CULTURAL RESOURCES OFFICE PRESERVATION BOARD REGULAR MEETING – ZOOM MEETING WEDNESDAY JULY 29, 2020 — 4:00 P.M.

Approval of June 2020 Minutes.

EXISTING SASH REPLACEMENT WINDOWS

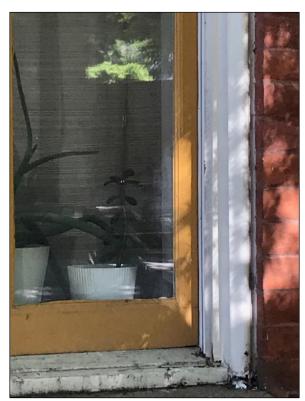
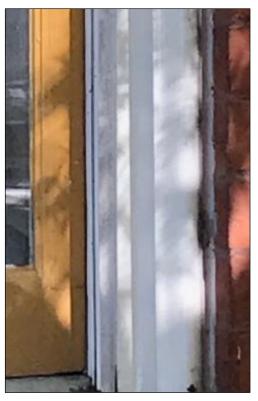
Does not comply. Proposed sash replacements require jamb liners, which are prohibited. Jamb liners when used with sash replacements are usually visible from the exterior, unlike integral jamb liners in a full-frame replacement window.

- The proposed site for the window replacement, 1432 Dolman Street, is located in the Lafayette Square Local Historic District.
- The proposed sash replacements would replace existing sash replacement windows.
- The proposed sash replacements would use a jamb liner, which is prohibited under the Lafayette Square Historic District standards.
- Unlike the integral jamb liners, the jamb liners on sash replacements have a higher visibility.

Based on the Preliminary findings, the Cultural Resources Office recommends that the Preservation Board uphold the Director's Denial of the windows as they do not comply with the Lafayette Square Historic District Standards.

EXISTING REAR DECK

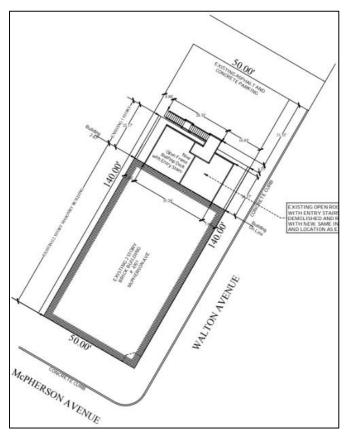
Partially complies. The deck is constructed above a one-story addition at the rear of this two-story building. It is, however, clearly visible from Walton Avenue. The design of the deck is not compatible with the building to which it is appended nor does it follow any historic porch design. Due to the use of the rear as a parking lot and height of the deck, screening it with landscaping or opaque fencing to limit visibility is not possible.

- 4701-03 McPherson Avenue is located in the Central West End Local Historic District.
- The existing deck was approved under previous Central West End Local Historic District Standards but does not comply with the current Standards
- The proposed deck does not replicate a historic deck and cannot be partially screened due to its elevation and site conditions.

Based on these preliminary findings, the Cultural Resources Office recommends that the Preservation Board uphold the Director's Denial to replace the rear deck as it does not comply with the Central West End Local Historic District standards.

PROPOSED SITE PLAN FOR THE RETAINING WALL

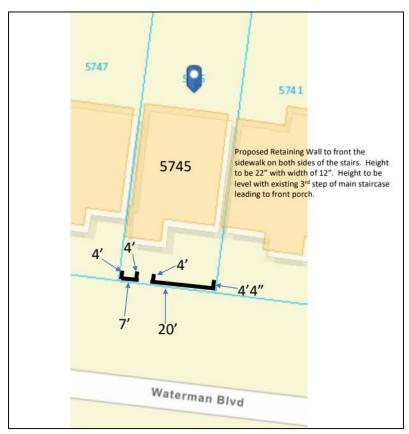
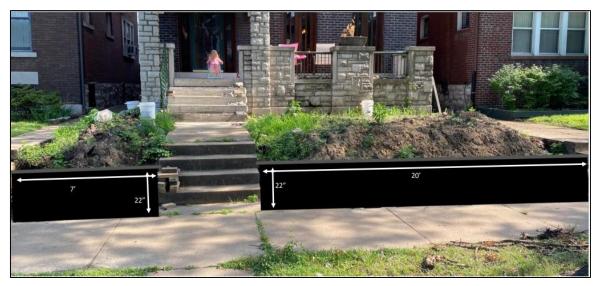
- Does not comply. The proposed front retaining wall is on a block where less than 50% of the properties on the block have altered the Earth Terrace. No accessibility ramp is proposed.

- Does not comply. The proposed retaining wall is in front of the street facing façade and is more than 8 inches in height.
 - e. No new Visible landscape or retaining wall shall be constructed of non-masonry materials, such as wood timbers. Exposed cast-in-place concrete and concrete block may be used but shall be faced with brick or stone that is of the type, shape, coursing, as common in historic walls in the district, and laid with mortar. Dry-laid stone, ashlar style coursing, and stone that is not in a block shape are not commonly used and shall not be approved.

- Does not comply. The proposed wall with be constructed of cast concrete units of varied sizes and staggered coursing, not brick or stone of the type, shape and coursing

Does not comply. The proposed retaining wall does not have a cap of stone or brick.

Based on these preliminary findings, the Cultural Resources Office recommends that the Preservation Board uphold the Director's Denial of a permit to construct a retaining wall as less than 50% of the block terrace has been altered and therefore the project does not comply with the Skinker-DeBaliviere Historic District Standards.

5291 LINDELL BOULEVARD

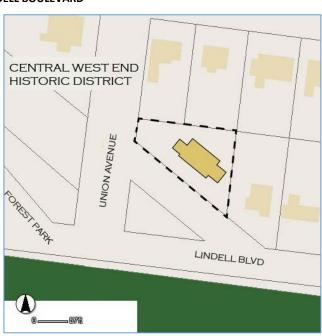
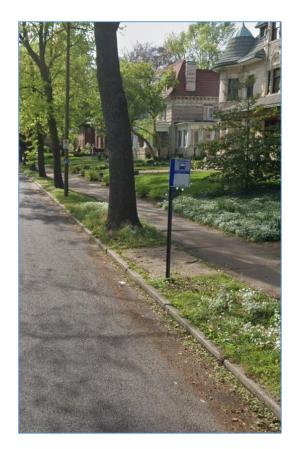
The construction is of substantial height that it is essentially a fence/wall. The standards prohibit opaque fences/walls in front of the house. The construction is incongruous with design of the streetscape.

- A Stop Work Order was issued by the Building Inspector.
- The construction is incongruous with the historic streetscape.
- The opaque wooden structure is equivalent to a low wooden fence and is prohibited within the historic district.

Based on these preliminary findings, Cultural Resources Office recommends that the Preservation Board uphold the Director's denial, as the construction is incongruous with the streetscape criteria of the Central West End Historic District Standards.

PROPOSED SITE PLAN FOR THE RETAINING WALL

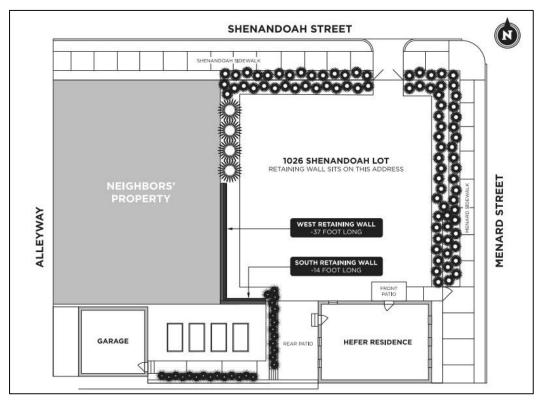
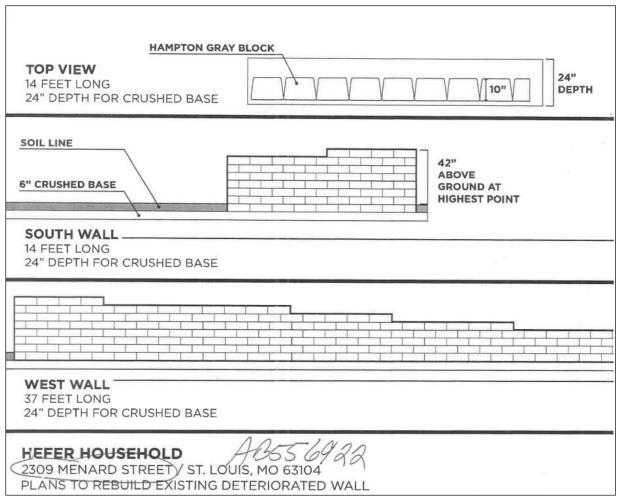
Does not comply. Although the wall height is 48" or less the concrete masonry unit material does not comply.

Does not comply. The proposed wall is not based on a Model Example and the use of concrete block as a material for the wall is prohibited.

Based on these preliminary findings, the Cultural Resources Office recommends that the Preservation Board uphold the Director's Denial of a permit to construct a retaining wall as the wall is not based upon a Model Example and the proposed material does not comply with the Soulard Local Historic District Standards.
